FERRY LANDING AT BEACON, LTD.

October 23, 2017 Beacon City Planning Board 1 Municipal Center Beacon, NY 12508

Ferry Landing at Beacon Beekman Street Beacon, NY 12508

In regards to the comments received from the City of Beacon's consultants, please find the following response:

(NEW) BEEKMAN AT FERRY ST.

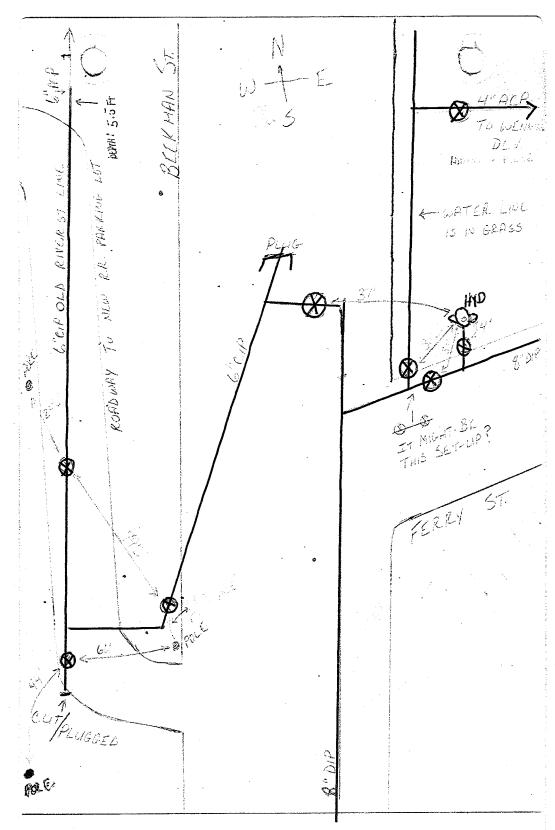
- 1. The catch basins and storm drains have been revised. No portion of the collection system is now located in the right of way.
- 2. The City of Beacon Water Department was contacted to provide a detailed mark out for all the water mains and valves in this area. The Water Department did not want to provide this type of time consuming detailed mark out because they felt it was not relevant to the proposed water service connections. The water Department did provide two (2) copies of as built sketches (copies enclosed) for the water mains and valves on Beekman Street and Ferry Street.
- 3. The down spout collection system has been removed from the front of the building.
